**REPORT FOR  
Gleason Hills Subdivision  
Plymouth, Connecticut**

Environmental Review Team Report

Plymouth Inland Wetlands Commission

AUGUST 1988

Figure 7

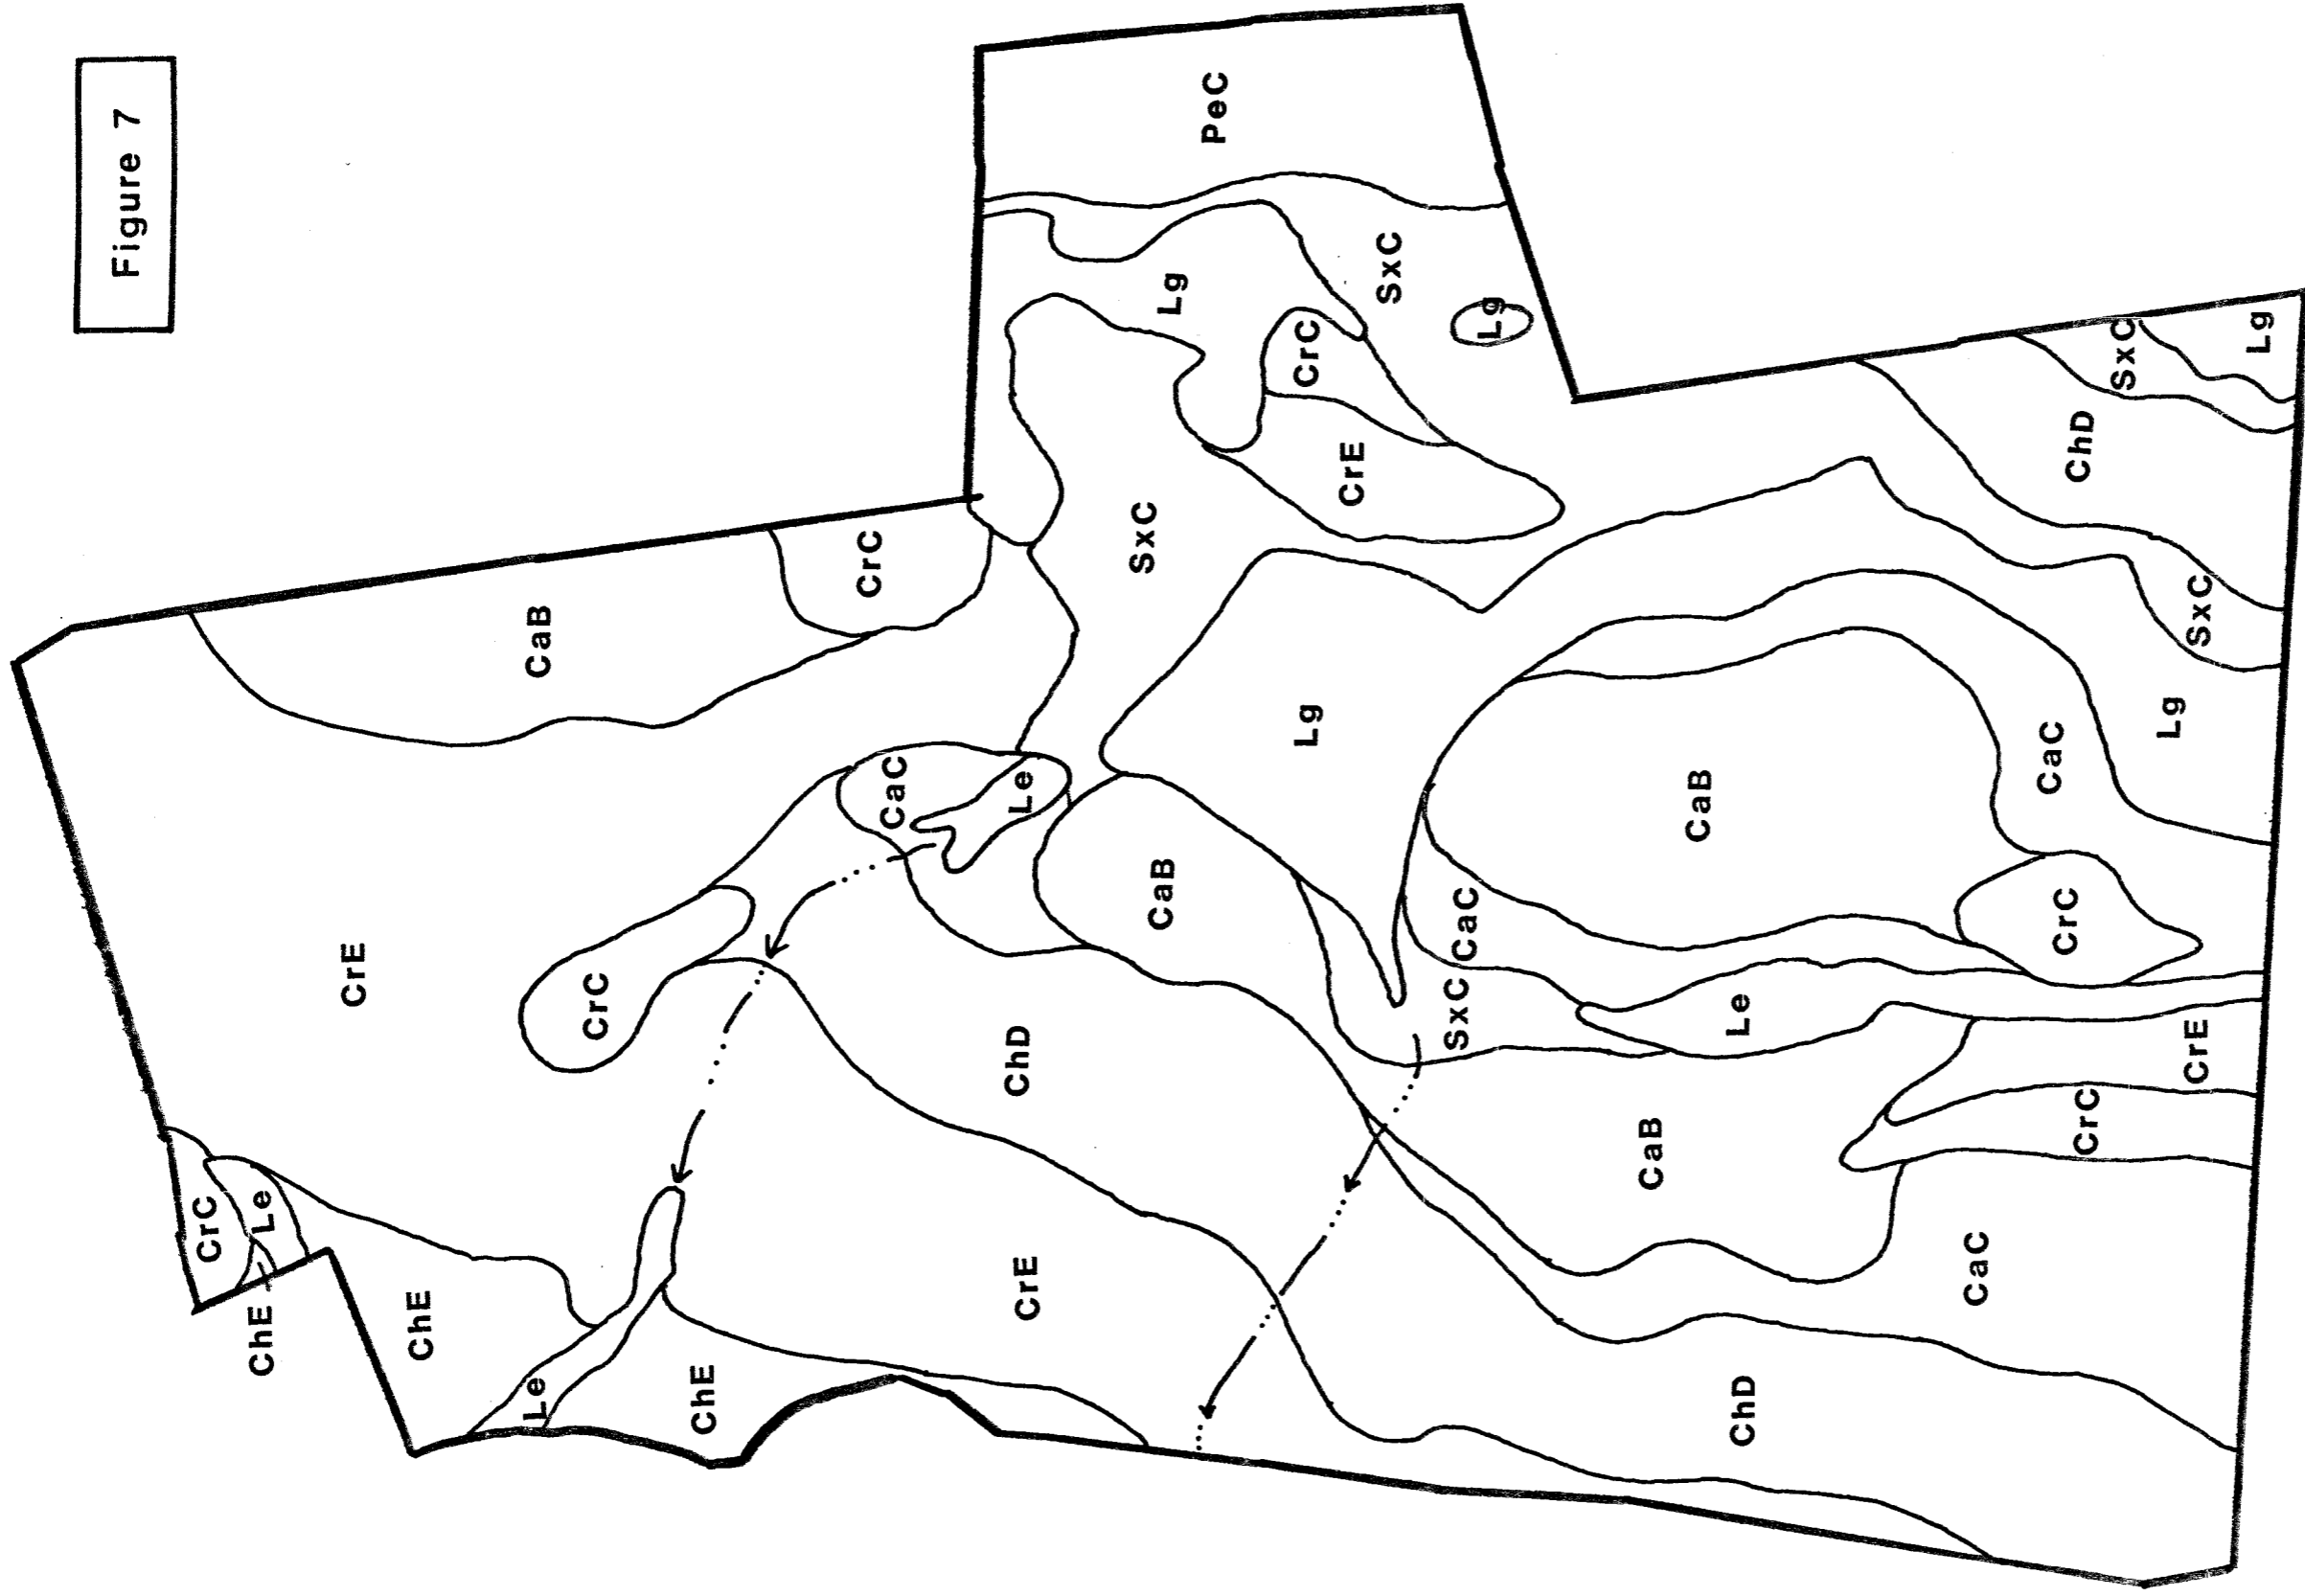
- 1) Many of the map units dominated by Charlton soils may be shallower to bedrock (>72 inches) than is typical for the series. Also included are areas with a firm dense substratum.
- 2) Included in areas mapped CrE and CrC are areas of soils moderately deep (20 to 40 inches) to bedrock.
- 3) Wetland boundaries do not match between plan sheets 6 of 16 and 9 of 16.
- 4) Additional wetland soil areas and watercourses are on Lots 21, 22 and 28. These should be investigated and mapped by the soil scientist.
- 5) Numerous side hill seeps and possibly additional wetlands and/or watercourses are in the vicinity of the intersection of David Drive and Elaine Drive.

- 6) Numerous side hill seeps are in the area south of Lot 39 and will present engineering limitations. A number of these seeps appear to coalesce into a watercourse that is not shown on the plans.

- 7) No culverts are shown for the wetland crossing between Lots 25 and 28.
- 8) No culverts are shown for the wetland crossing of Elaine Drive between Lots 15 and 20.

- 9) Portions of the primary septic system for Lot 18 are on the old access road. These compacted and disturbed materials may not be suitable for the leach field.

- 10) The home for Lot 28 is located in the topographic low-watercourse. This is unacceptable. The septic system is on the sideslope of the "swale" and is too close to the cutslope.

- 11) The home for Lot 8 is proposed too close to the top of the steep slope. Site work could impact the slope and create an erosion hazard.
- 12) Extensive cutting and filling is proposed for many roads and driveways. Portions of Heather Drive, Gleason Lane and Lots 28, 29 and 30 will result in steep sideslopes that will be difficult to stabilize and maintain. A road layout and common drive layout that better follows the contours of the slope should be considered.
